## **SECTION 4.55(1A) MODIFICATION APPLICATION BUILDING R4B – SSD 8892218**

This modification application has been prepared by Ethos Urban on behalf of Lendlease (Millers Point) Pty Ltd, pursuant to section 4.55(1A) of the *Environmental Planning and Assessment Act 1979* (EP&A Act) to modify Development Consent SSD 8892218 relating to Building R4B Barangaroo South (the site).

**Figure 1** Proposed reconfiguration of UB-03

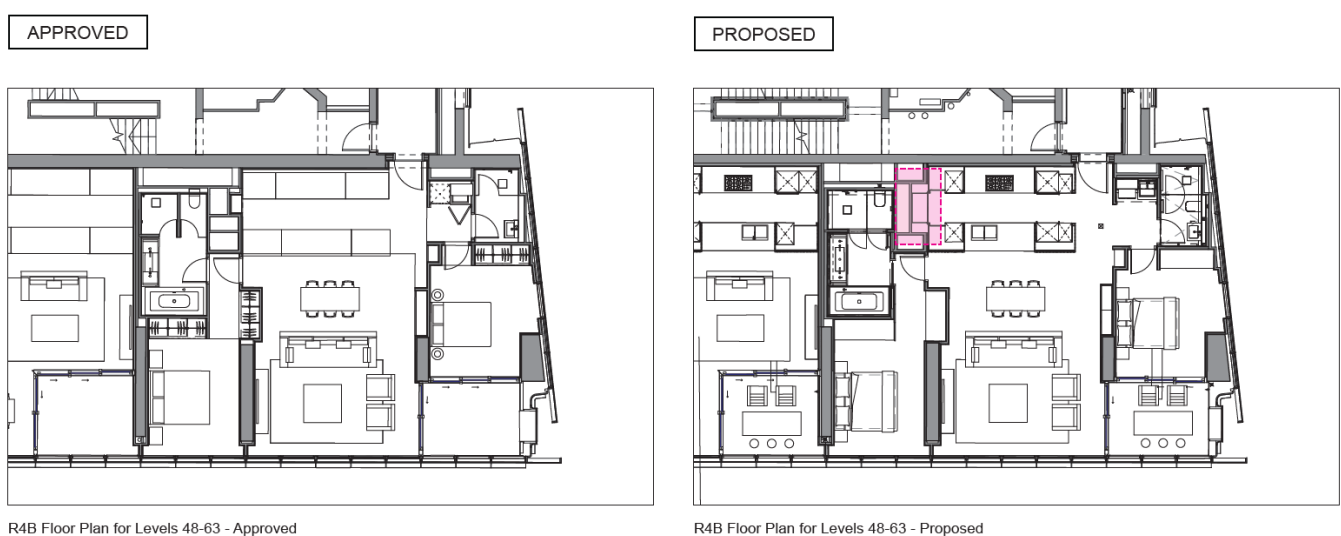
A minor reconfiguration of apartments type UB-03 on Level 48-62 is proposed to incorporate a cupboard to accommodate home automation utilities. This reconfiguration applies to 15 apartment and the change is illustrated in **Figure 1**.

**Figure 3** Level 64 reconfiguration

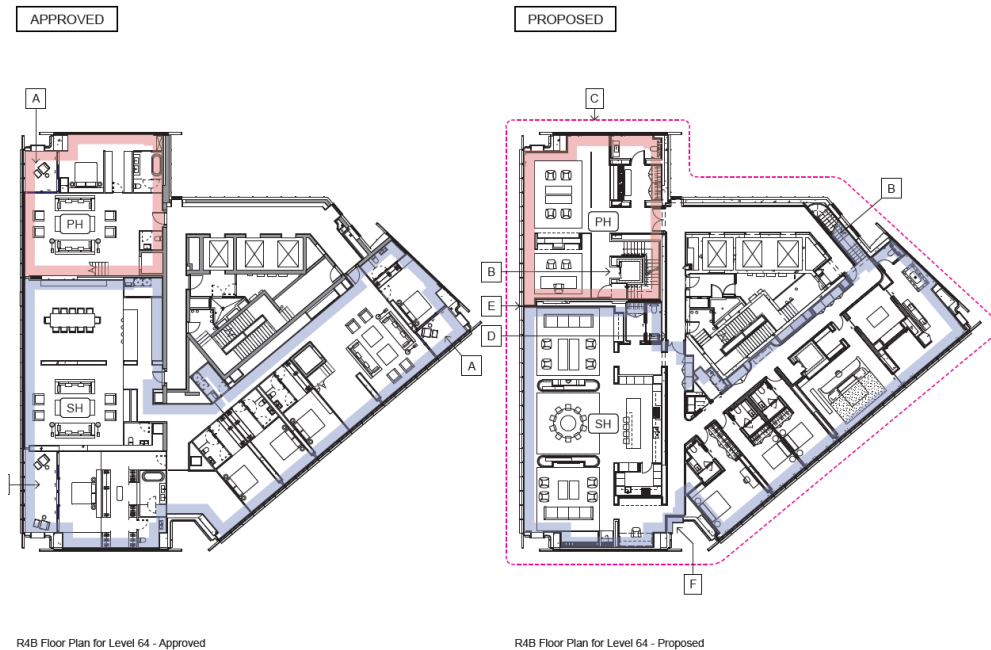
### Level 64

#### *Current 'SH 01 Skyhome'*

A reduction from 5 to 4 bedrooms, with relocation of master bedroom from north west to south west corner. Apartment entry door adjusted, removal of winter gardens and overall associated internal changes including stairs to Level 65. Apartment title amendment from SH 01 (Skyhome 01) to SH (Skyhome).

#### *Current SH 02*

Internal reconfigurations including removal of a bedroom and apartment title amendment to PH (Penthouse).

The proposed reconfigurations are shown in **Figure 3** and **Figure 4**. It is noted that no changes to the overall gross floor area of the development will result from the amendments.

This modification application also seeks to reduce the finished floor level of Level 64 and increase the finished floor level of Level 65 by 50mm. This will not impact the finished floor levels of Level 63 below.

**Figure 4** Level 65 reconfiguration

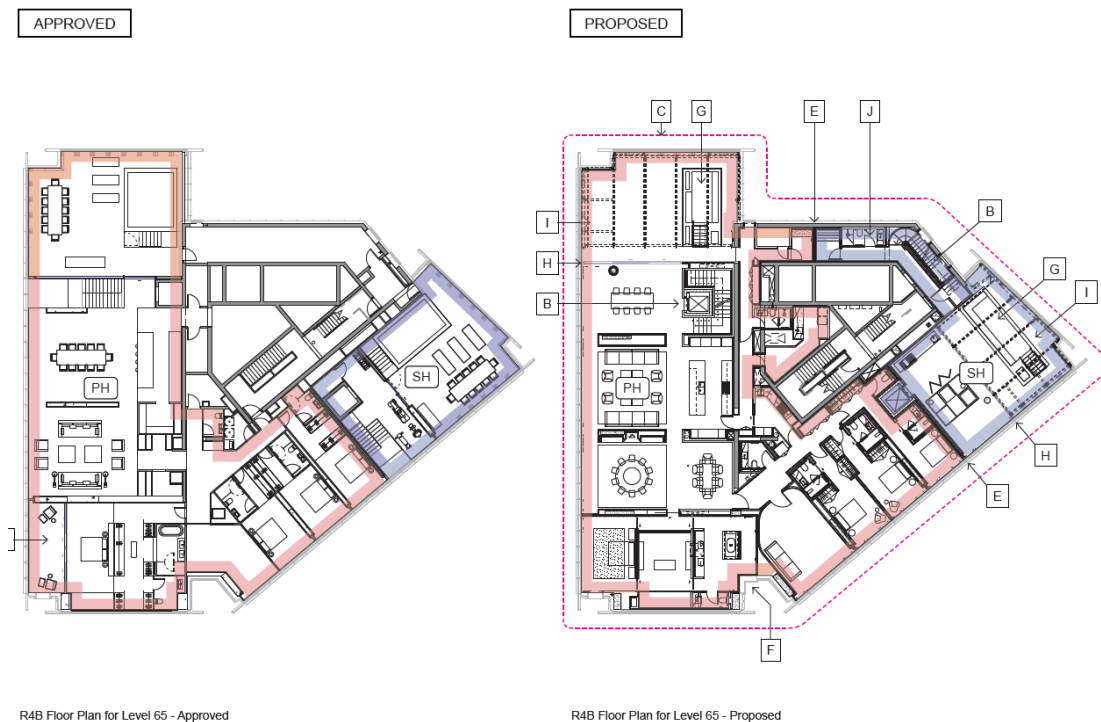
## Level 65

Current 'SH 01 and SH 02 Skyhome'

Internal reconfigurations, removal of wintergardens, reconfiguration of outdoor terraces. Associated apartment title adjustments to SH (Skyhome) and PH (Penthouse).

**Figure 5** Refined rooftop plan

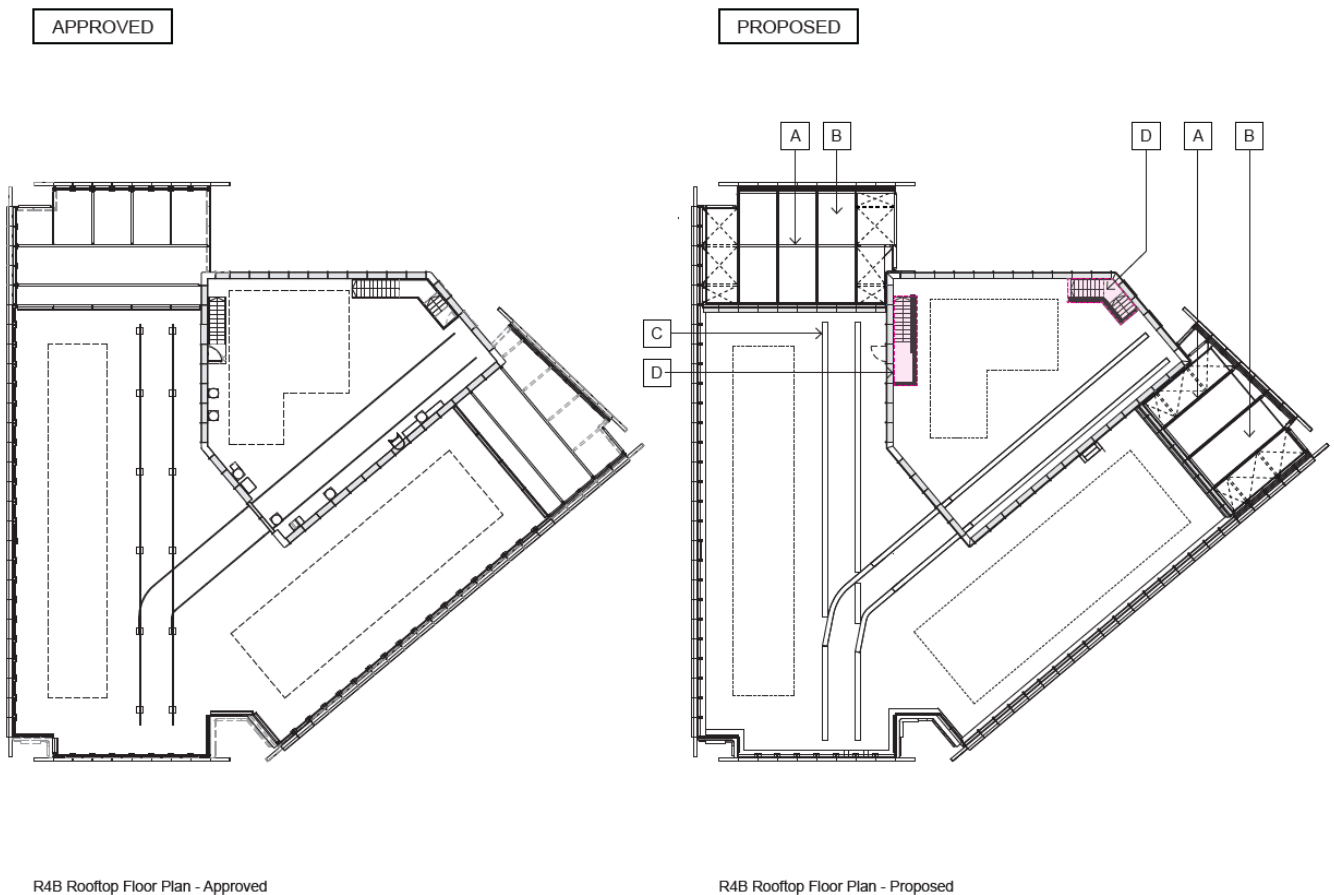
The rooftop has been the subject of design development, with a number of minor reconfigurations now proposed, including:

- Refinement of the double height steelwork design.
- Refinement of the sun shading above Level 65 outdoor terraces.
- Refinement of the building maintenance unit (BMU) rails and parking location.
- Revised upper roof stairwell voids.

These changes are shown in **Figure 5**.

**Figure 6** North-eastern elevation changes

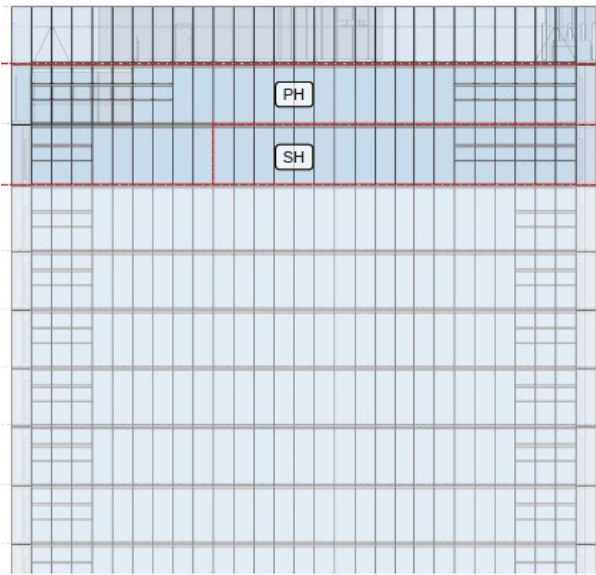
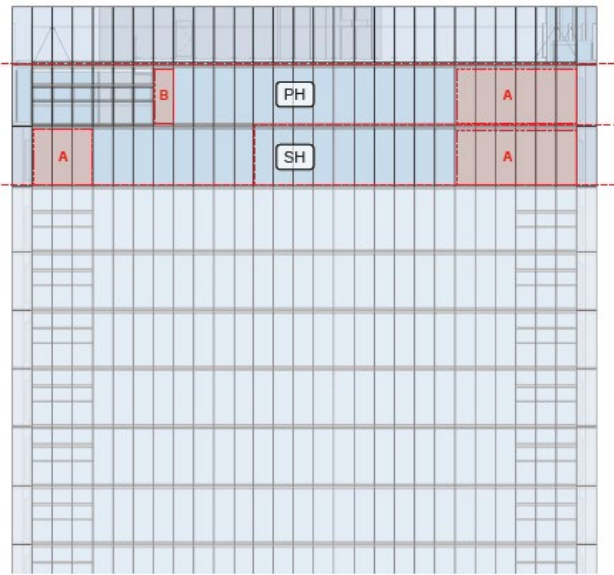
As part of the reconfigurations proposed on Level 64-65, a number of façade changes are proposed to the north-eastern and western facades. These changes include replacement of wintergarden panels with open cavity façade panels, which reflects the internal reconfiguration outlined above. These changes are shown in **Figure 6** and **Figure 7**.

Wintergarden facade panels replaced with OCF

**Figure 7** Western façade changes

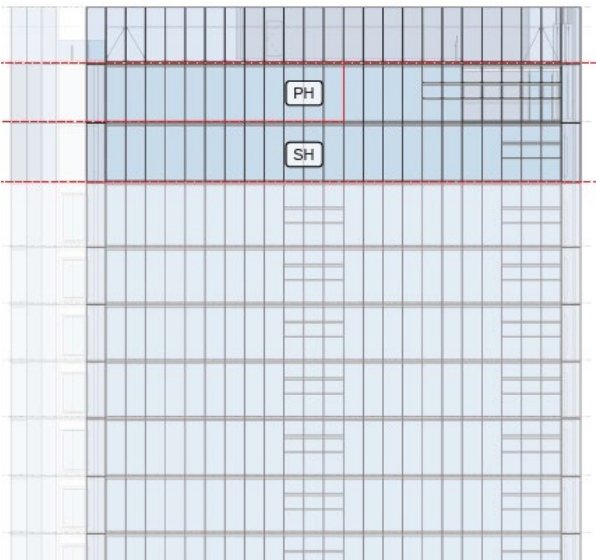
Window added

Wintergarden facade panels replaced with OCF
